Z-COM

AG-621 V1.0

(MB32 - Mini PCI Type IIIB Card 802.11a and 802.11g Combo Radio)

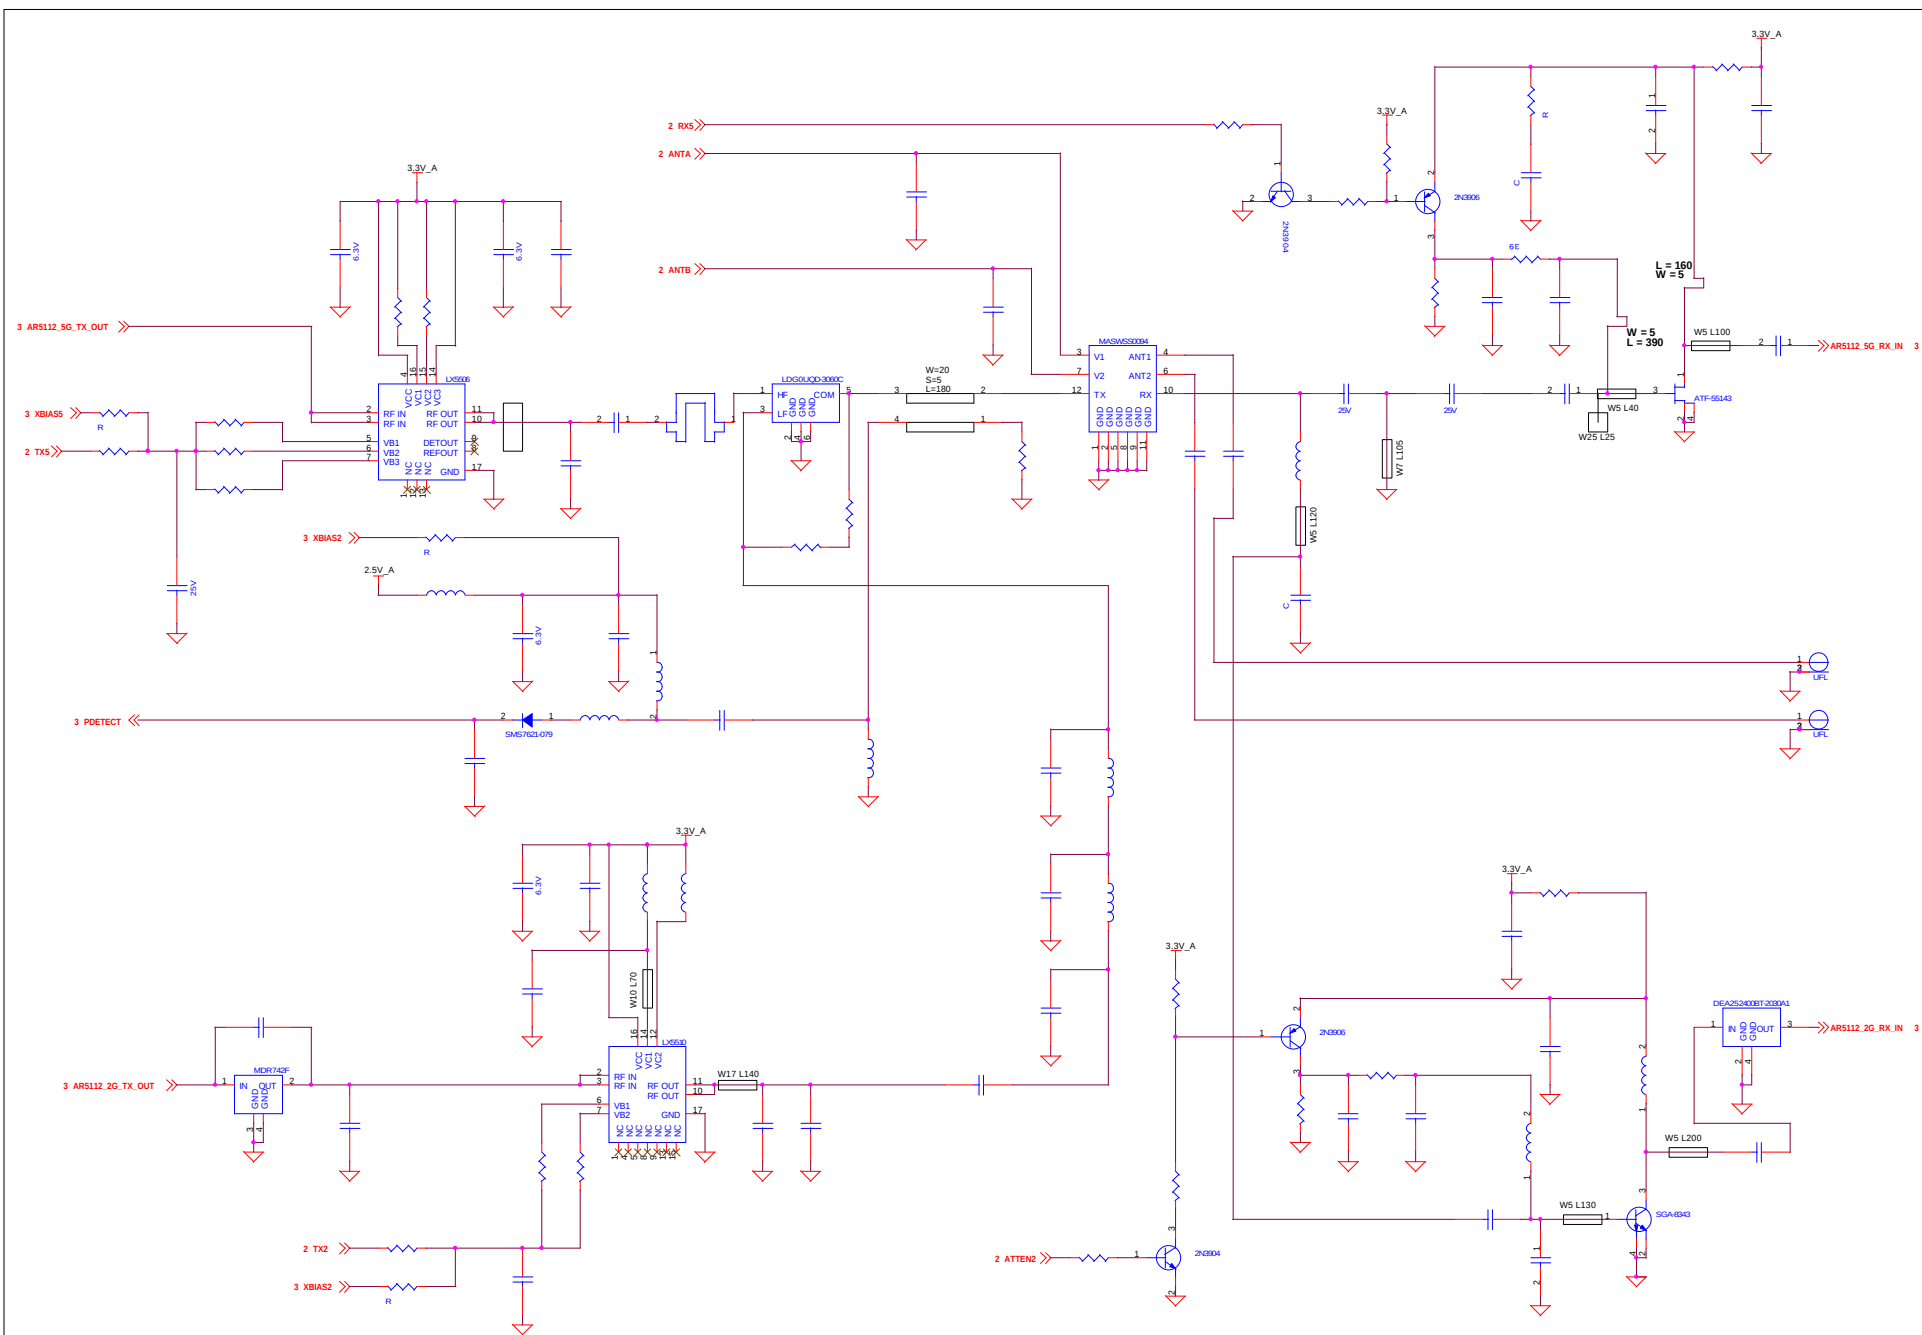
DATE	REVISION NUMBER	INITIALS	DESCRIPTION
02/10/03	245-01184-010, Rev 000	JW	Initial release.
03/28/03	245-01184-020, Rev 000	VN	Modified Sch based on 245-01184-010 Rev.A Rework. Changed R39 to 330. Changed R89 to 150. Changed R50 to 348. Changed R51 to 200. Changed C142 to 1pF. Changed L29 to 3.3nH. Changed C143 to 1.5pF. Changed C113 to 2.2pF. Changed C110 to 3.3pF. Changed Q11 to DNI. Changed Q12 to DNI. Changed R5 to DNI. Changed R9 to 0. Changed R23 to 3.09K. Changed F8 to MDR742. Changed R63 to 28.7K. Changed C114 to 2.7pF. Changed C91 to 1pF. Removed C62, C67. Added L41, L42 : 3.3nH. Removed C81, R30, C85, C92, C89, C90, C84, L21, R37, R40. Added R107: 100, 1% ; R108: 620, 1% ; R109: 910, 1% ; R105: 10 ; R106: 10. Added C346: 1uF; C347: 1uF; C348: 220pF; C350: 0.5pF. Changed U4 to LX5506. Changed F3 to DEA205425BT-2028A4. Removed R91, R62, Q9. Removed R16 ; connected L12 to 2.5V_A. Added C144: 1uF ; L43: 15uH. Changed L25 to 2.2nH. Added L44: 1.8nH. Added R112: R.

5/20/03	245-01184-030, Rev 000	VN	Added WoL circuit. Added BlueTooth support.
